Mclvors Road, Kilmore

Stormwater Management Strategy

GOULBURN BROKEN CATCHMENT MANAGEMENT AUTHORITY (GBCMA) LETTER

**Stormwater Management Strategy – McIvors Road Kilmore (Dec 2019)
(South-East Precinct of the Kilmore Structure Plan)**

Figure 4-4 Green Link Road Typical Cross-Section

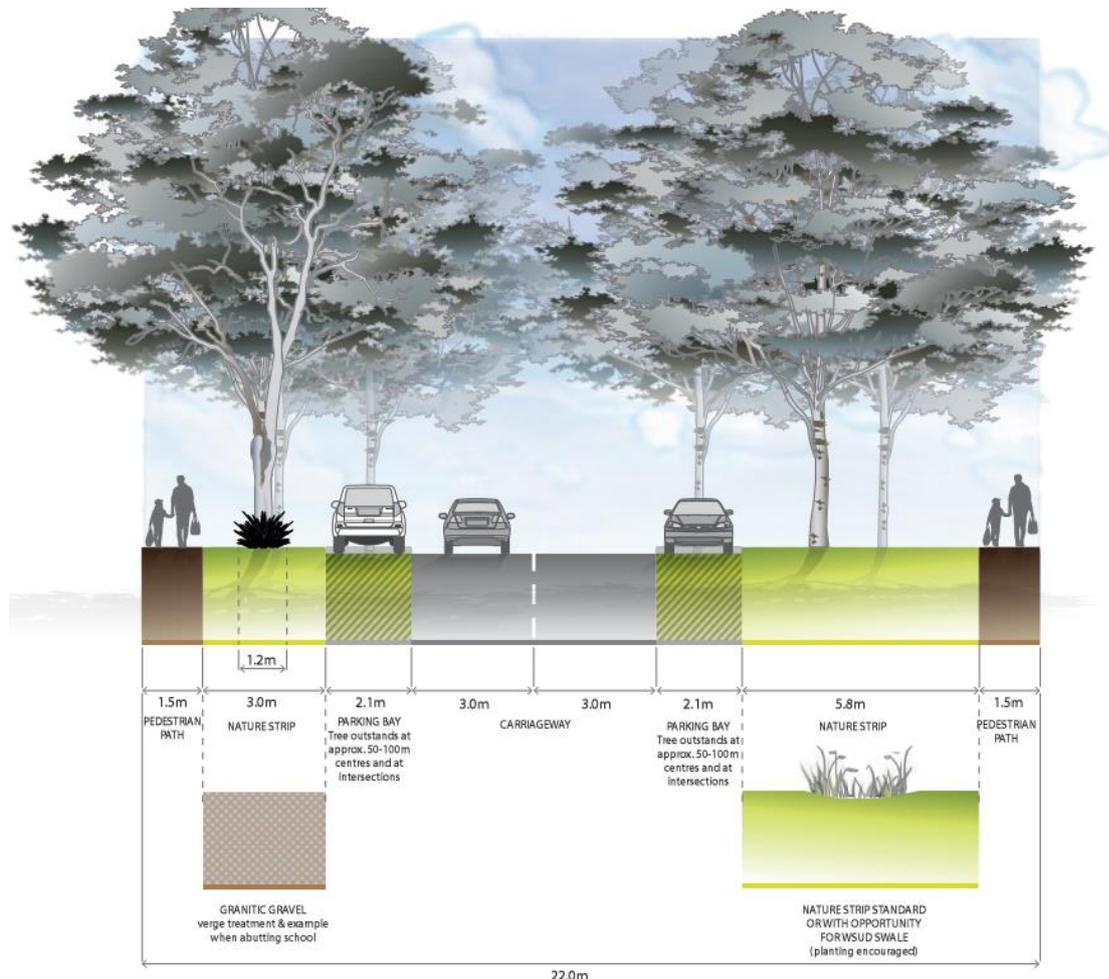
- a. Predominant waterways are aligned along its natural alignments within a 60 metre wide corridor. This is more acceptable to the Goulburn Broken CMA. The exceptions are small sized catchments (east of the site) that are to be re-aligned with a combination of a low-flow pipe and swale known as the “green-link”, and minor drainage lines further west.

- b. The smaller eastern catchments are generally ill defined in terms of “bed and banks” that provide particular constraints for stormwater management options that led to the “green-link” strategy.

Figure 6-1 Final Drainage Concept Plan

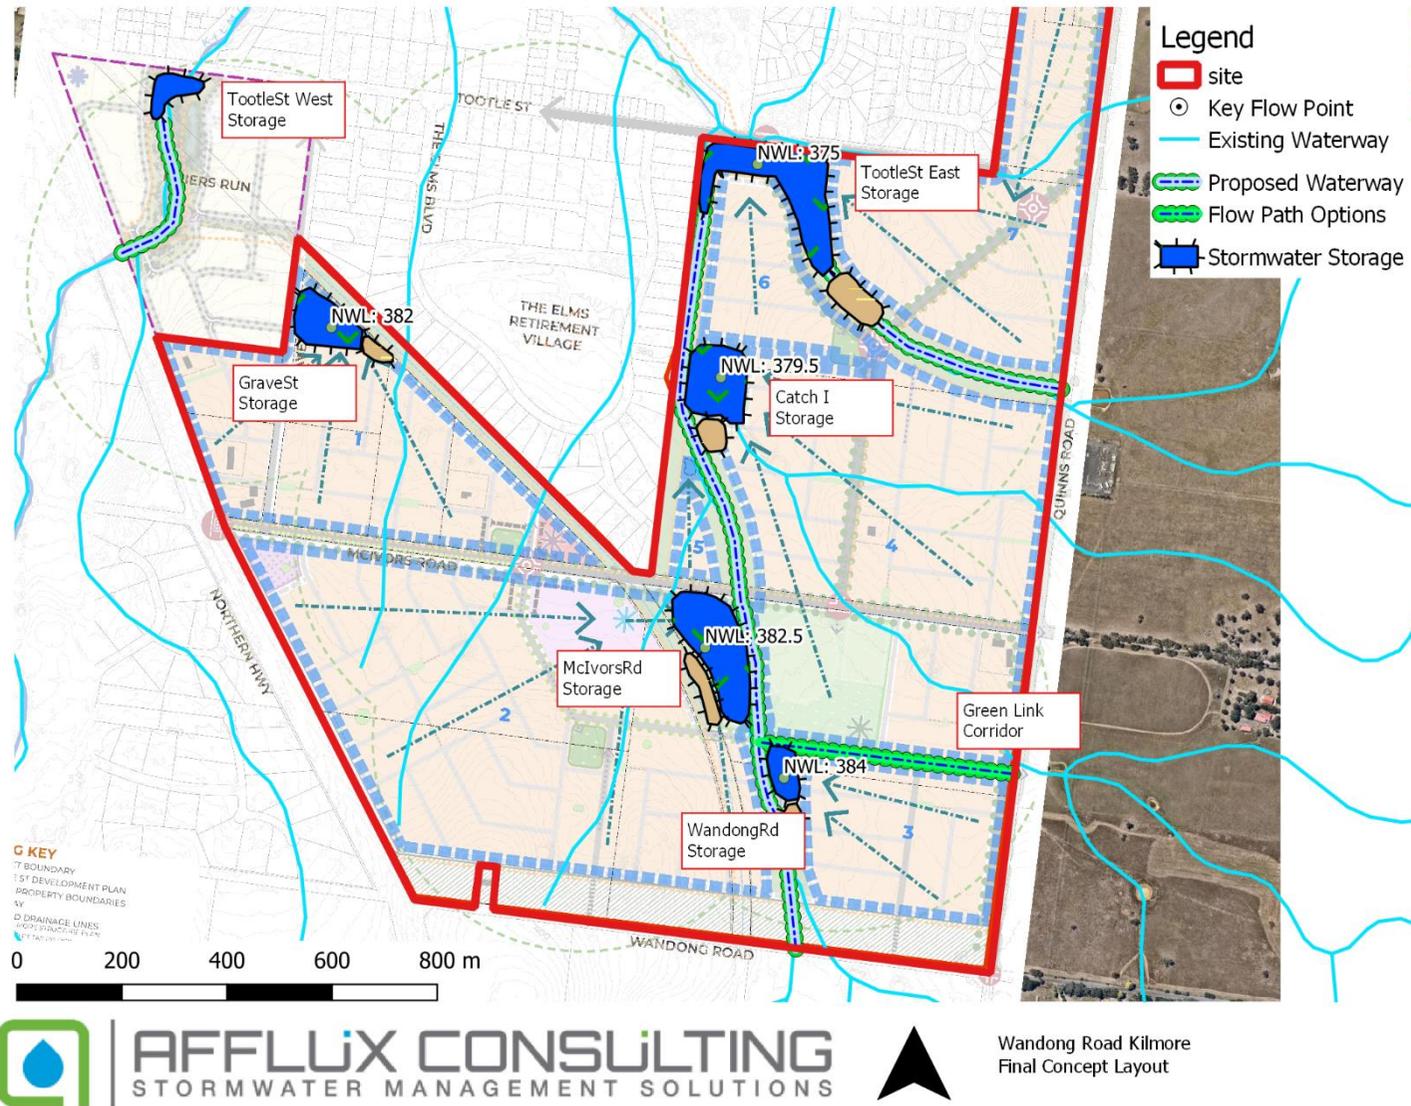
2. From our discussions, it was explained that your Stormwater Strategy has somewhat departed from Figure 44 and is more aligned with the narrative of the Structure Plan, and:

- c. Stormwater water treatments and retardation basins are off-line.
 - d. Wetlands (flood storages) are provided at the downstream end of the development (Tootle Street East and West) to assist with treating flood impacts. This includes the Kilmore Creek that already has a drainage plan. The flood storage is to assist with managing flood impacts.

- g. To manage hydrologic changes, some waterways will need to be enhanced to ensure, amongst other things, intrinsic stability. It is noted that a straightened waterway-reach to Tootle Street West will need to be reinstated within a proposed 60 metre wide corridor – this is considered a positive way forward.

Having regards to the above on balance, the Goulburn Broken CMA in principle, supports the Stormwater Strategy (McIvors Road) subject to additional information to be documented within the strategy:

- 1) For the ultimate developed conditions, a hydraulic assessment (of the precinct, i.e. all stages) is to be included to establish/demonstrate holistically that the conceptual strategy:
 - Provides no “adverse” third-party impacts to downstream areas and the upstream areas of the proposed “green-link.”
 - Provide hydraulic parameters (i.e. discharge, velocity) is assist with geomorphic response together with a list of possible detailed design matters to be considered in detailed design phase such as soil types, grade reducing structure, etc.
- 2) For the ultimate developed conditions, an assessment of the viability of the proposed wetlands to ensure that proposed measures are ecologically sustainable in terms of required water volumes to support wetland flora, and without impacts to water quality and waterway health (including blue-green algae).
